LiDAR Quality Assessment Report

Materials Received: 5/1/2012	Project Type: Partnership			
	Project Description:			
Project ID:	This county is part of a 4 county USGS			
KS_3County_2010	agreement with Kansas (Harvey, Lyon,			
Project Alias(es):	Morris and Chase Co.). 11 more counties were delivered with the lot as donated			
KS 15 County dataset	data. Three reports will be delivered for the 15 counties - One for Harvey Co. (lot 1), 1 for Lyon, Morris and Chase Cos. (lot 2)and 1 for the remaining 11 counties (lot 3).

Lot 2 of 3 lots.

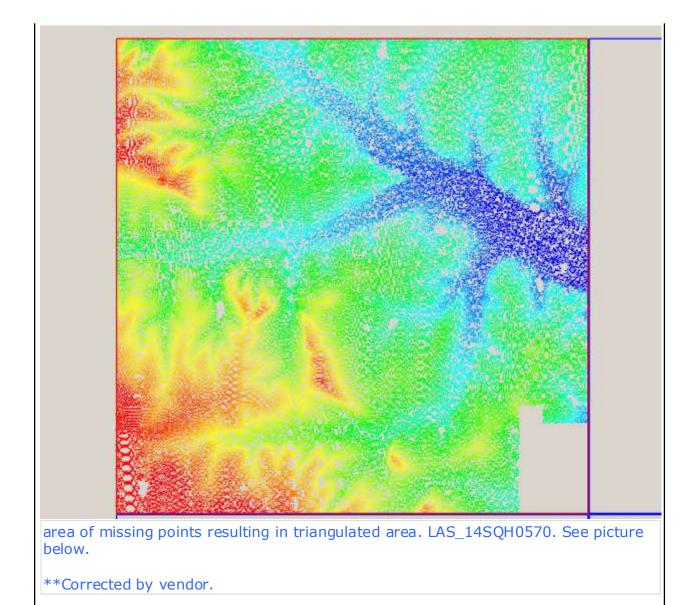
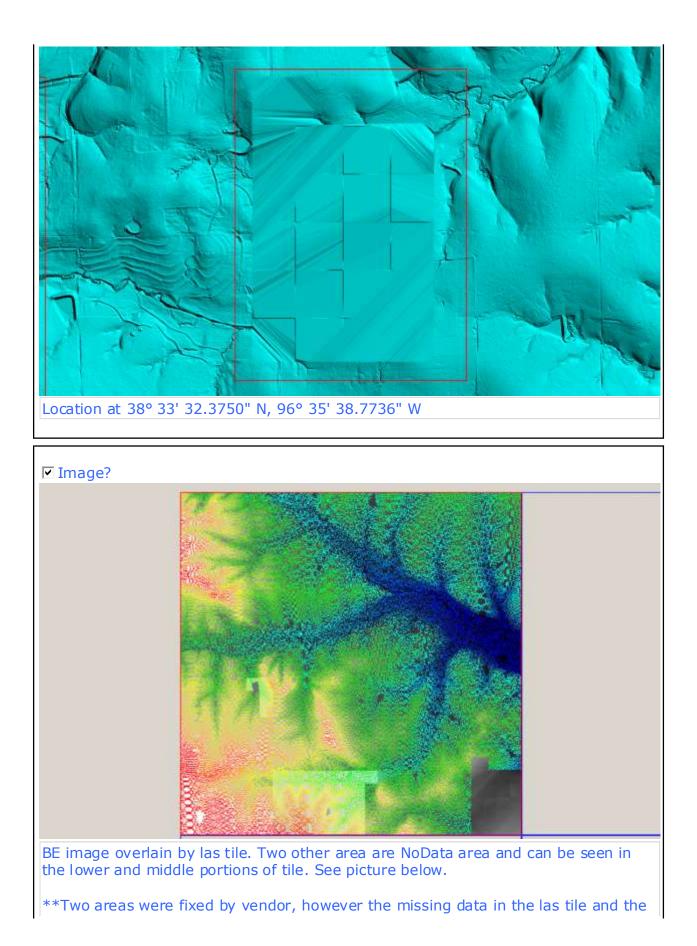
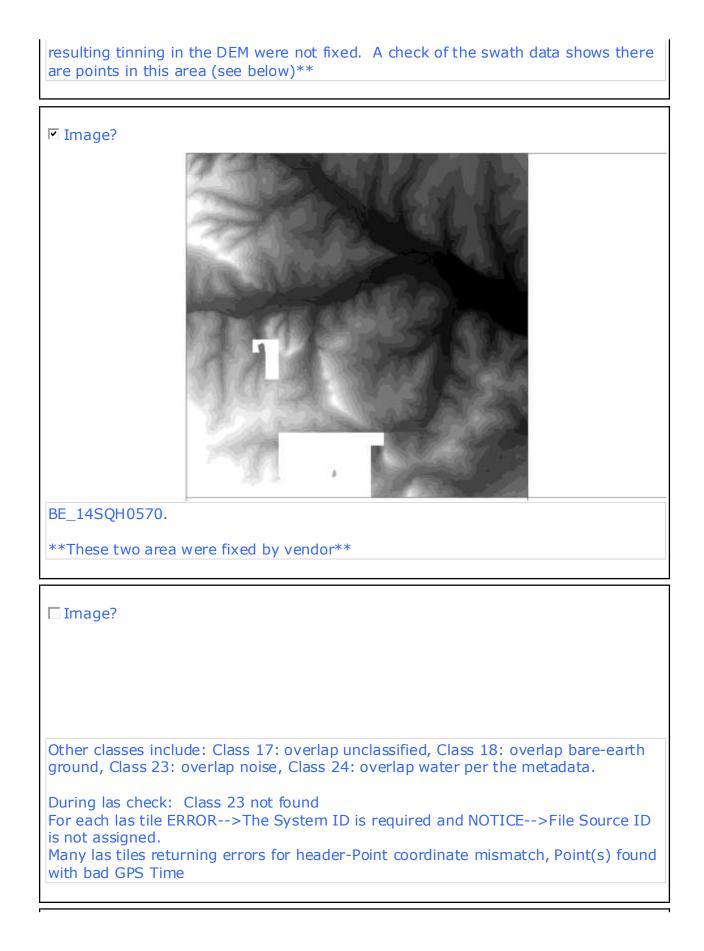
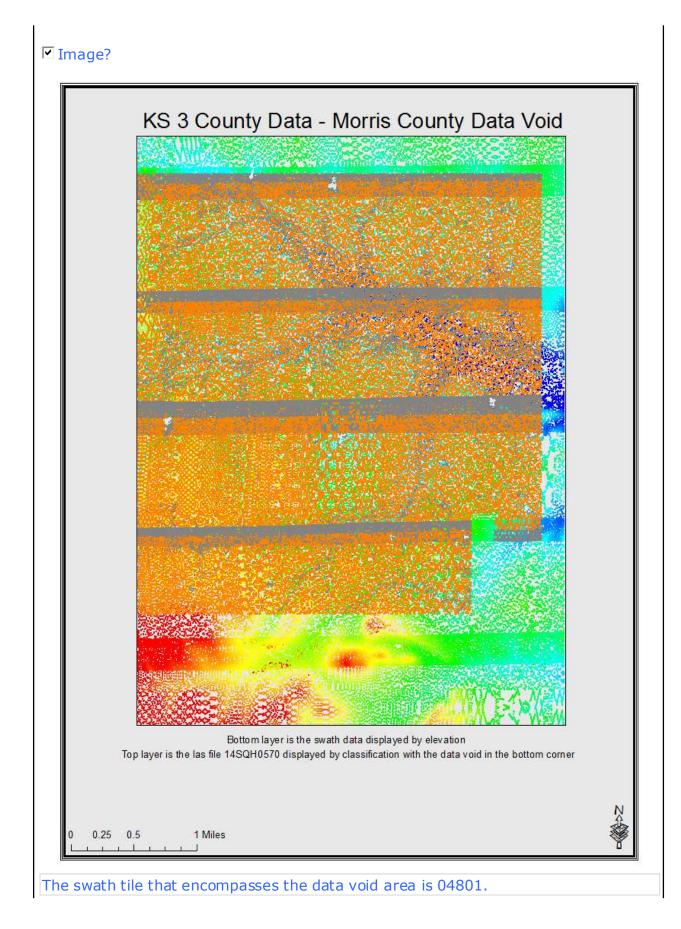
Missing points in the las file, NoData areas in DEM that are classified as ground in las. • Yes O No

The data void area was not corrected and still remains in the DEM and las.

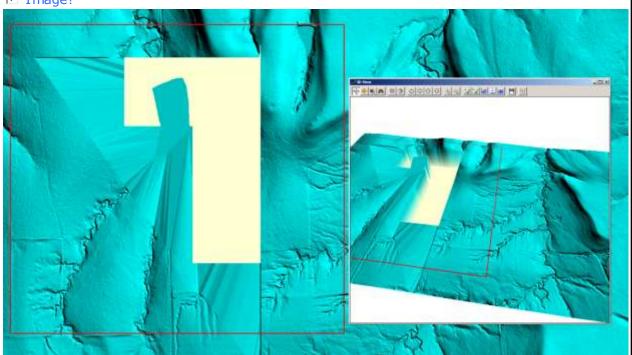
Several errors with water higher than the surrounding land. This is only a representative image. Not all these errors were recorded due to the high number found within the dataset. Location of this error at 38° 06' 31.2867" N, 96° 29' 6.3442" W

These areas were fixed by vendor

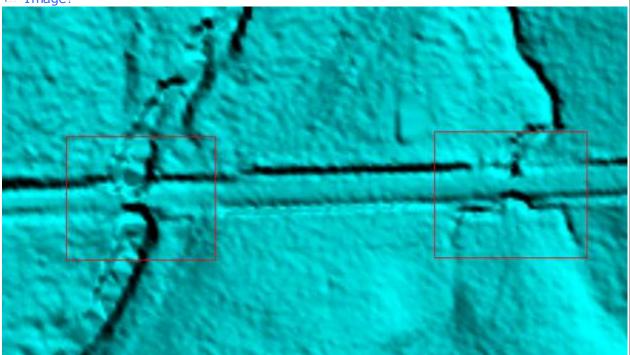
Data void areas mentioned above in classified las section. This displays a 3-D image to show what is happening in the DEM. Location at 38° 34' 24.1083" N, 96° 37' 58.6853" W

Vendor fixed this error

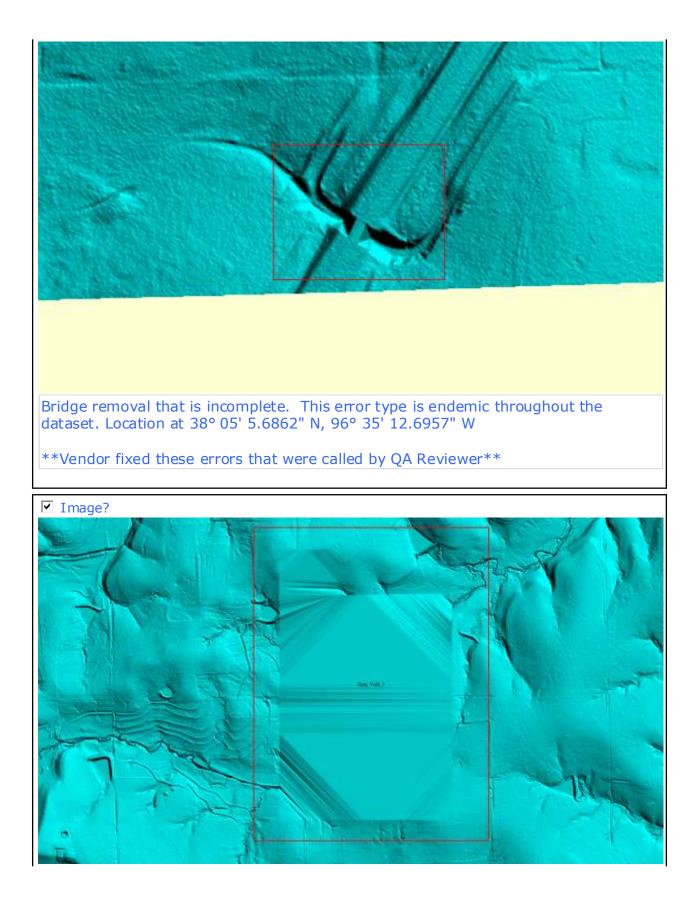
As with Harvey Co., several errors exist in dataset in which culverts were removed completely or partially as seen above when they should be left in data. This is a representative image of the errors. Only a few of this type of error were called due to it being endemic throughout. Location at 38° 05' 8.1436" N, 96° 49' 17.6969" W

Most of the culvert areas were fixed. 3 remain in which a culvert was removed partially
